## BOARD OF WATER SUPPLY

**Subject: Board of Water Supply (BWS) Comments on the Red Hill Bulk Fuel Storage Facility (RHBFSF) Administrative Order on Consent (AOC) Work Plans and Associated Scoping Meetings**

Figure 1  
 Additional Monitoring Well Sites  
 BWS Groundwater Study,  
 O’ahu, Hawai’i

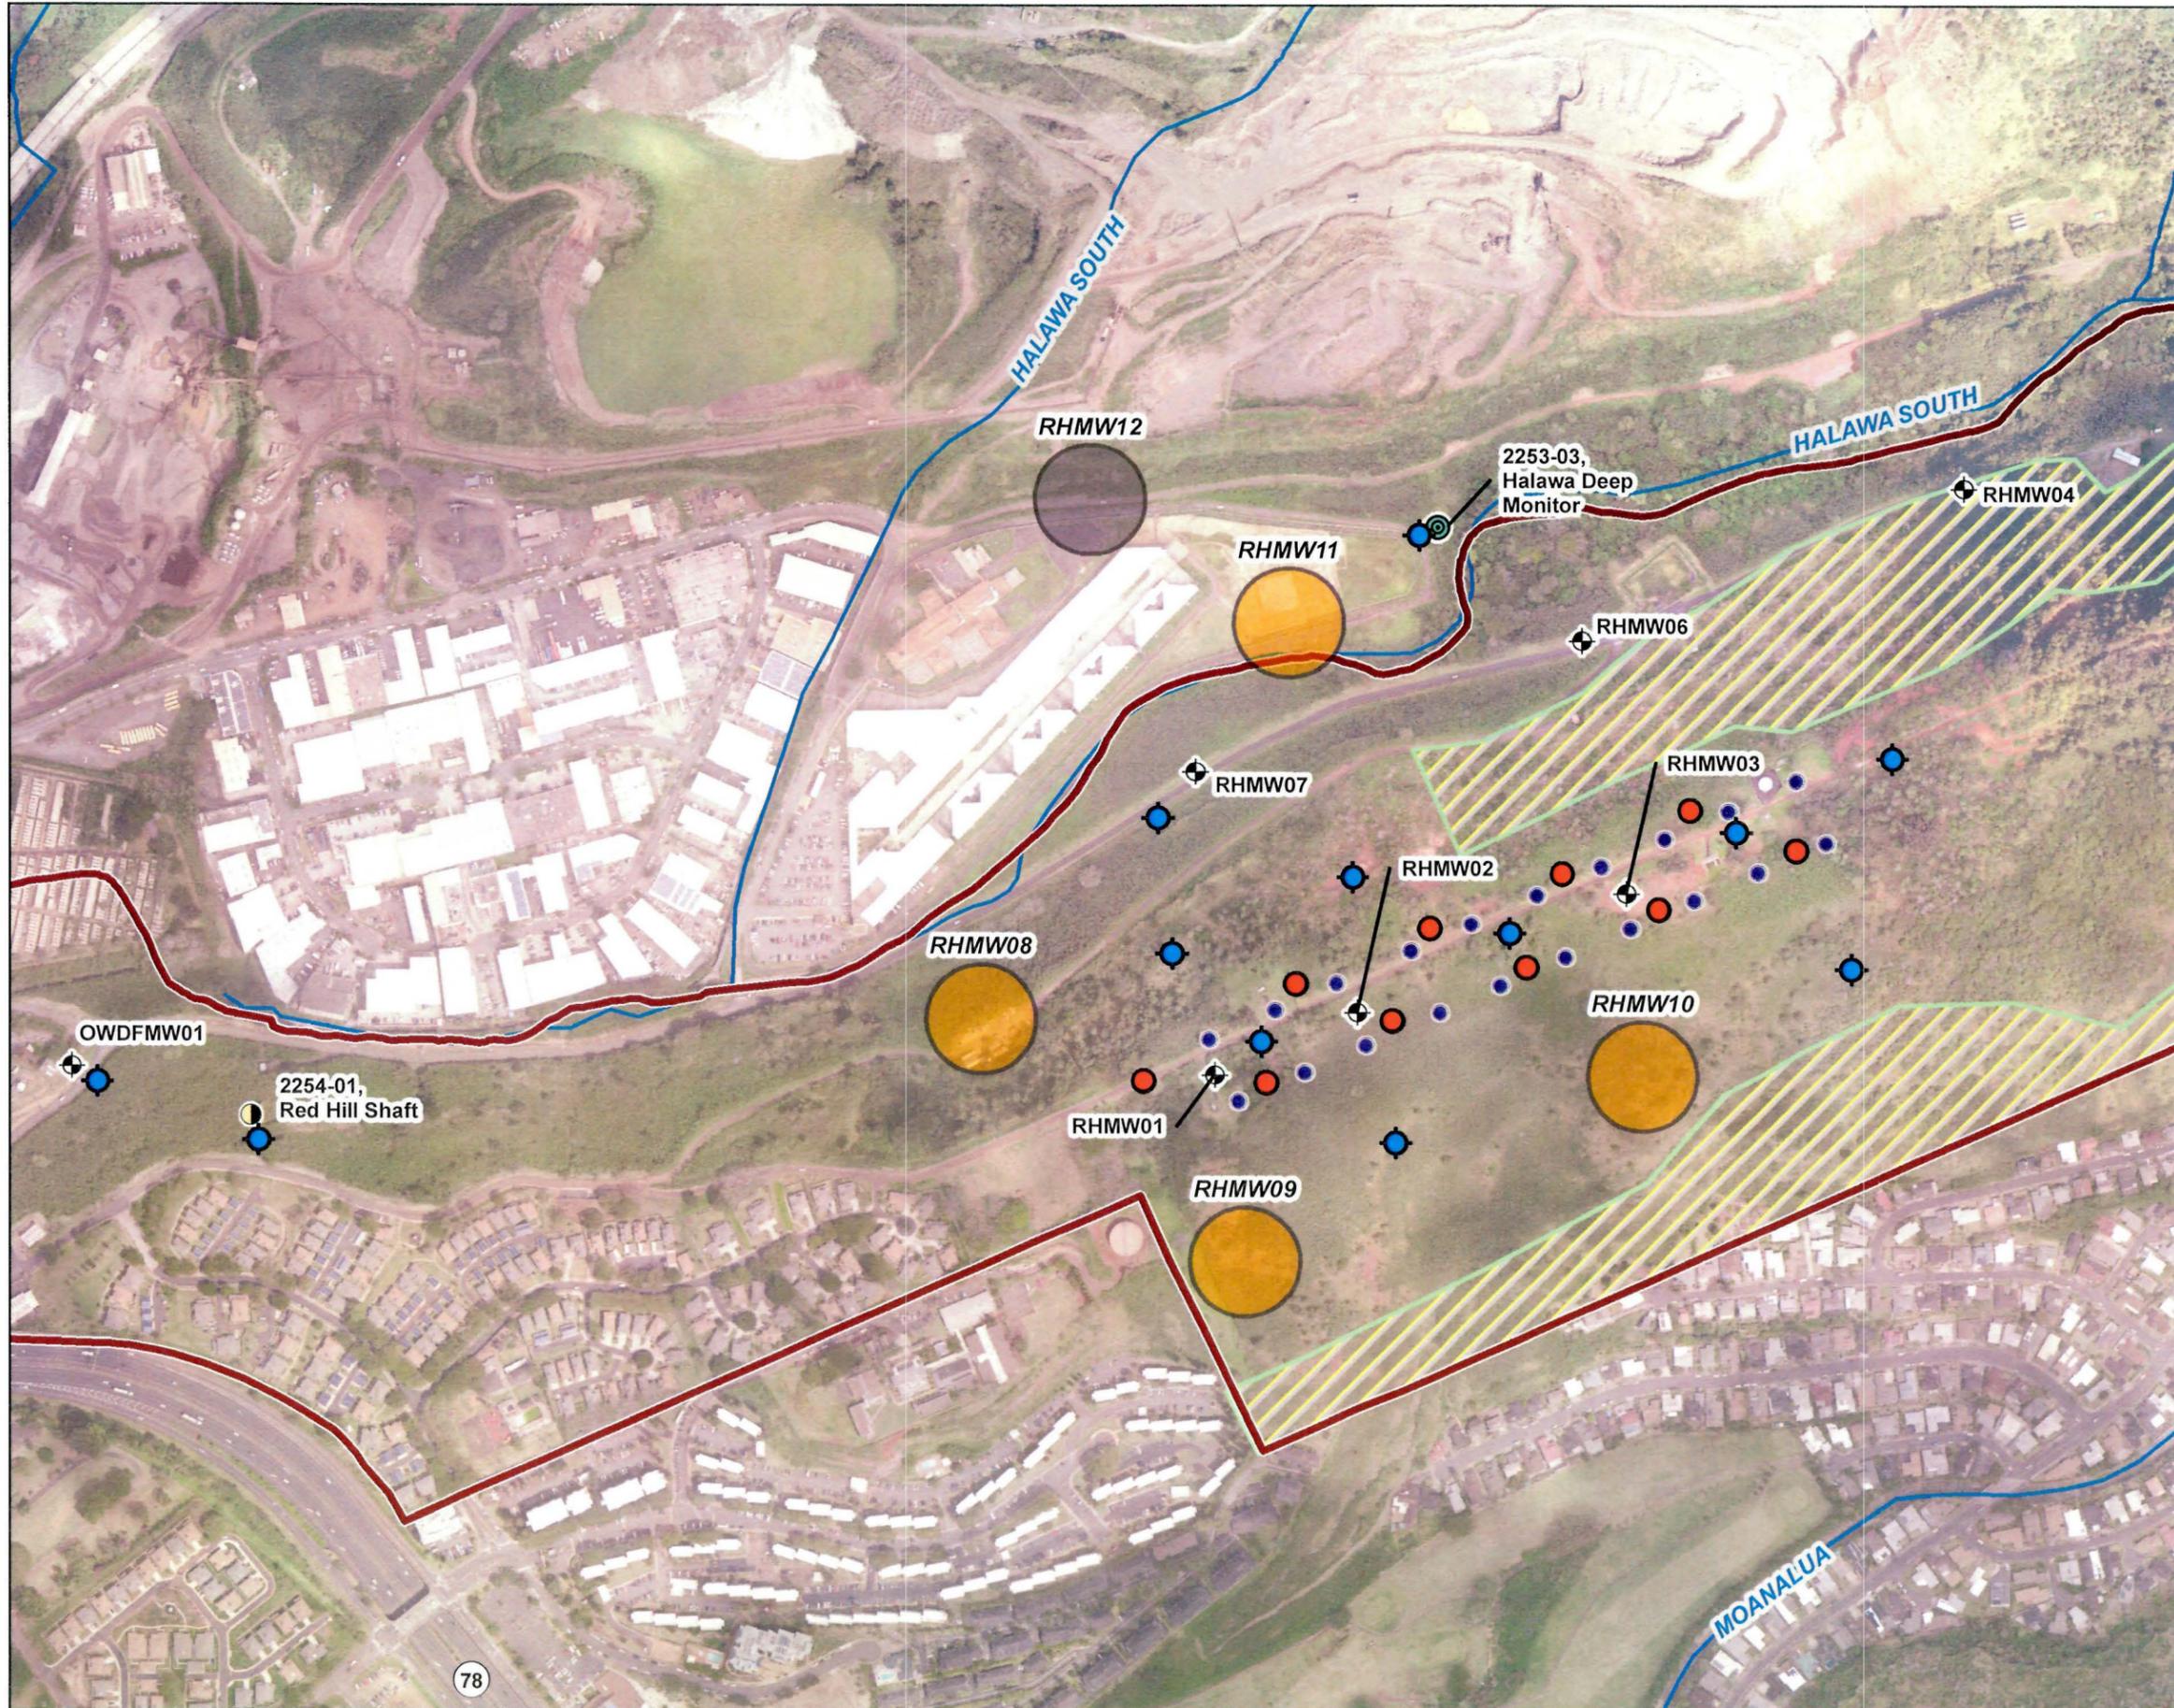
Given the geologic complexity and thickness of Ko'olau a'a and pahoehoe basalt flows that form the vadose zone beneath the Red Hill Facility, it is critical that a very thorough vadose zone investigation be conducted to understand where released fuel (from numerous historic releases and the most recent January 2014 release) has traveled in the subsurface. Also additional characterization of dissolved-phase contamination in the basal aquifer is necessary to assess the geometry of the current plume. Within the boundaries of the Navy property where the RHBFSF is located, a number of additional monitoring well site locations have been identified for both vadose zone monitoring wells and basal aquifer groundwater monitoring wells (see Figure 1). The red colored points represent locations for needed vadose zone monitoring wells and the blue colored points represent good locations for additional basal aquifer groundwater monitoring wells. All these proposed monitoring well locations assume that the Navy will install their proposed monitoring wells RHMW08 through RHMW11 as outlined in the Navy's Monitoring Well Installation Plan (AECOM, 2016).

The purpose of the vadose zone monitoring wells is to characterize the basalt vadose zone complexity and to install vadose zone monitoring wells to collect needed measurements of LNAPL and soil vapor. The purpose of the basal aquifer groundwater monitoring wells is to better characterize the dissolved-phase contaminant plume and to allow LNAPL measurement and groundwater sampling. Both vadose zone and basal aquifer monitoring wells would need to be constructed accordingly for data collection. Several of the proposed monitoring wells coincide with locations where monitoring wells already exist (and are being monitored), but there are issues regarding basal aquifer water level data collected from these existing wells. To address these issues, we have proposed installation of new water table monitoring wells adjacent to OWDFMW01 and the CWRM well HDMW2253-03 because fuel contaminants have been observed in

these wells even though they are open 12 ft. and 50 ft., respectively, below the water table. A new water table monitoring well should be constructed adjacent to monitoring well RHMW07 to confirm its much higher water levels.
